Engineering Change Notification

This notice is to inform you of a change to the following TFT products:

NHD-7.0-1024600AF-LSXP
NHD-7.0-1024600AF-LSXP-CTP
NHD-7.0-1024600AF-LSXP-CTPIM

NHD-7.0-HDMI-HR-RSXP
NHD-7.0-HDMI-HR-RSXP-CTU

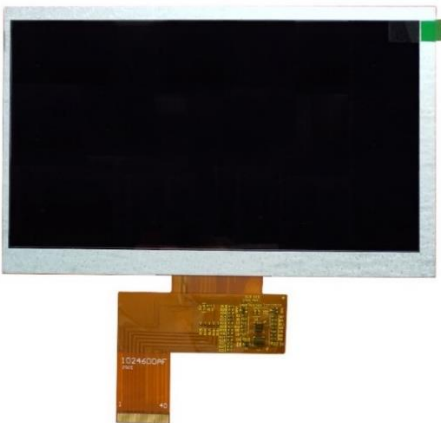
The display FPC has been redesigned to add EMI shielding for better EMC. The new FPC cable is also less susceptible to nicks and tears.

The new version does not require a change to the user's software or hardware design. The FPC size, shape and 40pin connection for the user remain unchanged.

The new displays will be labeled with a different revision control number after the part number. See example below.
